## **2.0 SITE CHARACTERISTICS**

This section provides details about the site location and site area description for the VEGP site. The proposed ESP Units 3 and 4 would be built on the VEGP site adjacent to existing VEGP Units 1 and 2. The 3169-acre VEGP site is located on coastal plain bluff southwest of the Savannah River in eastern Burke County. The site exclusion area boundary (EAB) is bounded by River Road, Hancock Landing Road, and 1.7 miles of the Savannah River. The site is approximately 30 river-miles above the U.S. Highway 301 bridge and directly across the river from the DOE Savannah River Site (SRS), in Barnwell County, South Carolina. The VEGP site is approximately 15 miles northeast of Waynesboro, Georgia, and 26 miles southeast of Augusta, Georgia, which is the nearest population center (with more than 25,000 residents).

Following the procedures described in RS-002, Section 2.1.1, the NRC staff reviewed Section 2.1.1 of the SSAR in the VEGP application regarding the site location and site area description, as well as the information the applicant provided in response to the NRC staff's RAI 2.1.1-2 and 2.1.1-3.

**Figure 2.3.2-1 - Vogtle 1998–2002 Hourly Stability Class Frequency**

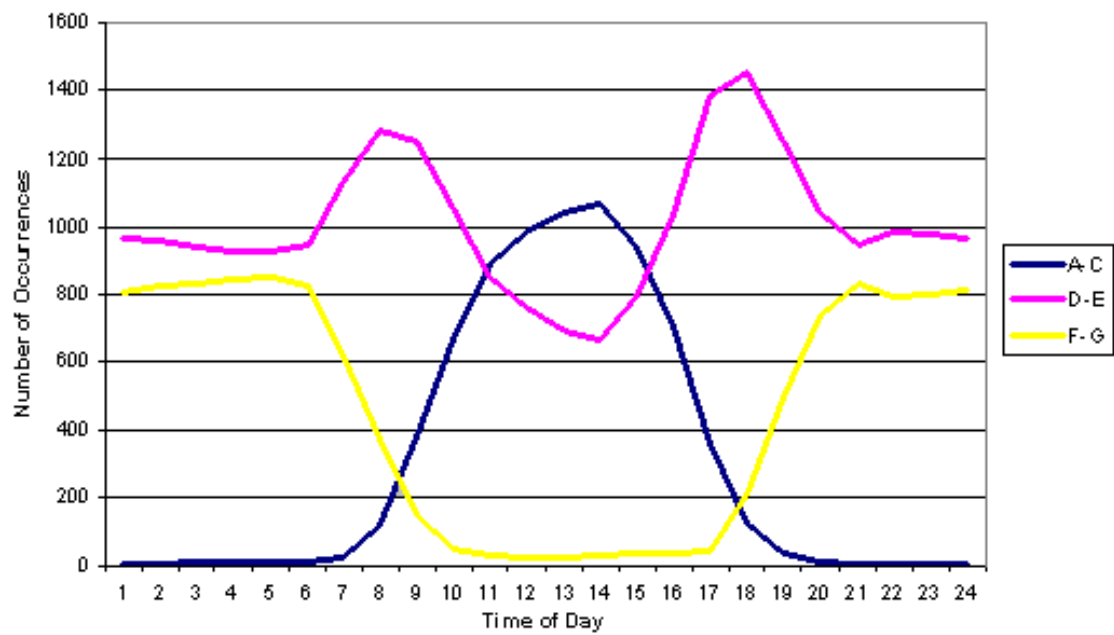
As a qualitative check of the hourly stability data provided by the applicant, the staff created plots of stability class as a function of time of day for each individual year, and, additionally, the 5 years together. SER Figure 2.3.2-1 is a plot of the proposed VEGP site 1998–2002 hourly stability class data as a function of time of day. Unstable conditions (Pasquill stability classes A–C) generally occurred during the day, and stable conditions (Pasquill stability classes F–G) generally occurred during the night, as expected due to daytime heating and nighttime cooling.

During a site audit conducted on December 6, 2006, the staff asked the applicant to explain a daytime increase in the number of occurrences of stable conditions (Pasquill stability classes F and G) in 2001, which is not seen in the other years. The applicant responded, in its letter dated January 30, 2007, that this could be attributed to a data error. This error was corrected in the revised meteorological database. The staff has confirmed that this problem has been fixed.

Figure 2.3.3-1 - Proposed Layout for VEGP Site

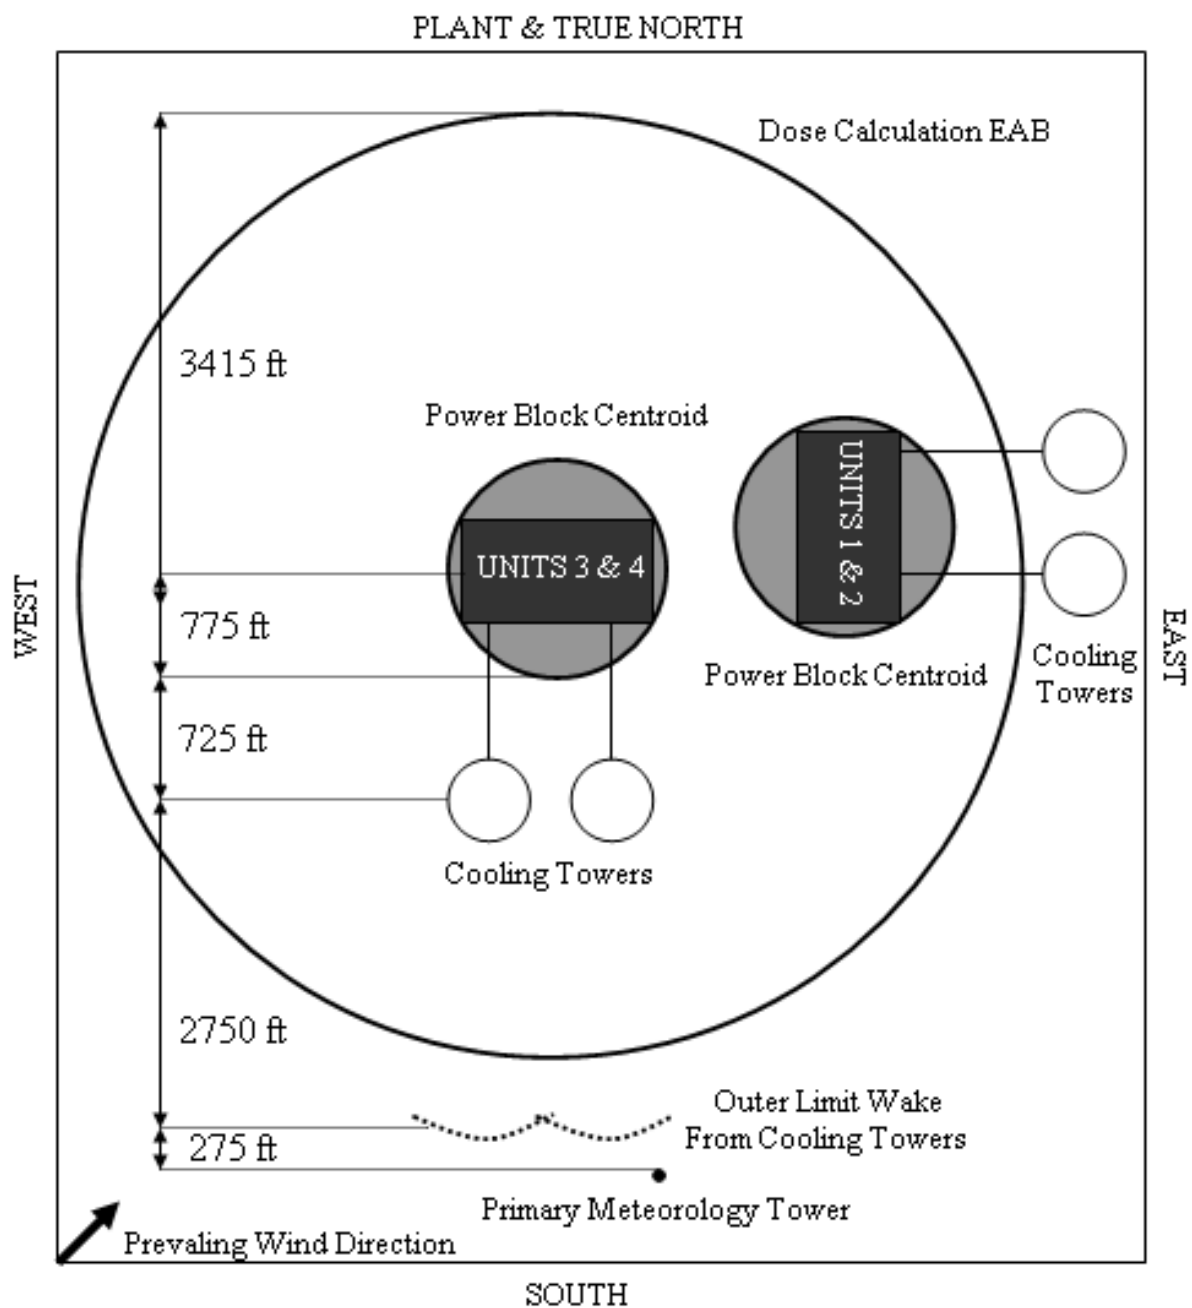
RG 1.23 indicates that obstructions to flow (such as buildings) should be located at least 10 obstruction heights from the meteorological tower to prevent adverse building wake effects. Since the height of the proposed reactor buildings is 234 feet above plant grade, the zone of turbulent flow created by the reactor buildings will be limited to about 2340 feet downwind. The staff concludes that building wake from the proposed reactor buildings will not cause any adverse effects on measurements because the meteorology tower is located 4525 feet south of the proposed power block area.

The base of the primary tower is at an elevation similar to plant grade for the proposed facility, and the ground cover at the base of the tower is primarily native grass. The applicant stated that it evaluated minor structures in the vicinity of the primary meteorological tower as having no adverse effect on the measurements taken at the meteorological measurement tower. After

conducting a site audit on December 6, 2006, the staff agrees with the applicant that the meteorology towers are sited in an appropriate area and these minor structures will have no adverse impact on the accuracy of measurements. The staff also noted during its site audit that the meteorology towers are located far enough from the surrounding tree line to prevent adverse effects on measurements. SER Figure 2.3.3-1 shows the proposed layout of the VEGP site.
